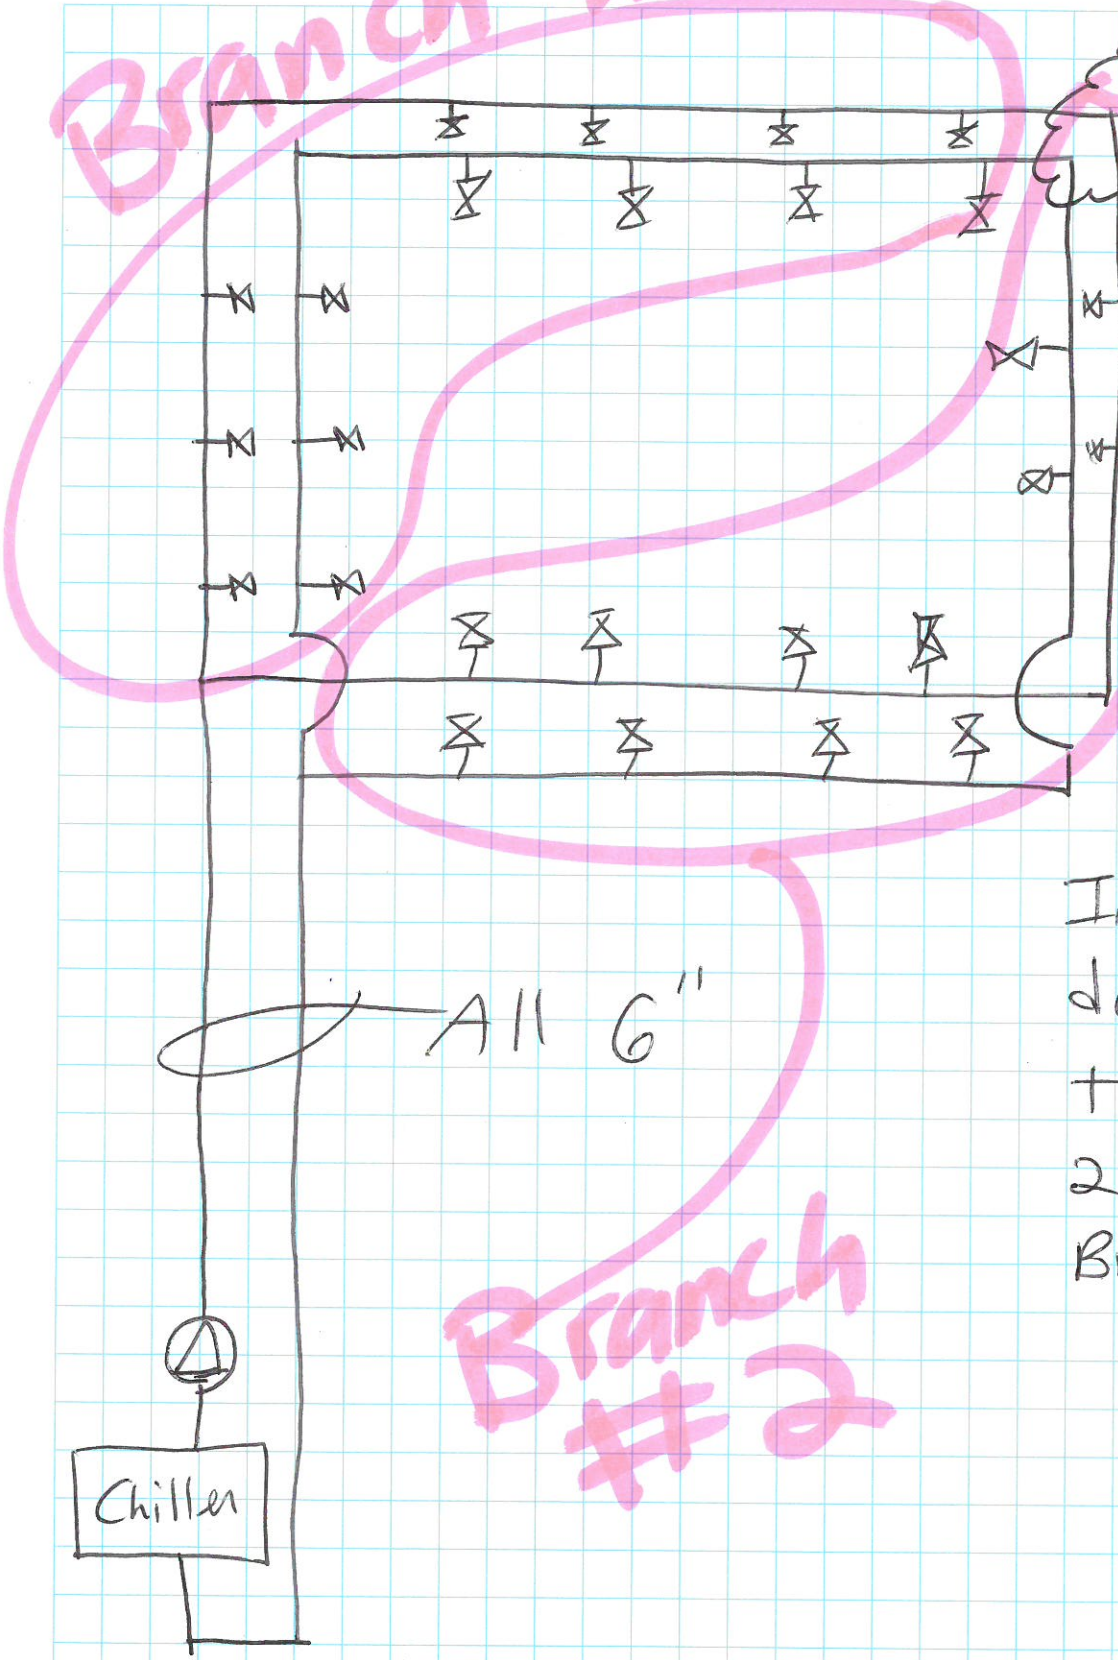
For hydronic calculations, Do I treat it as though these pipes are not connected?

In other words, do I treat this as 2 parallel Branches?
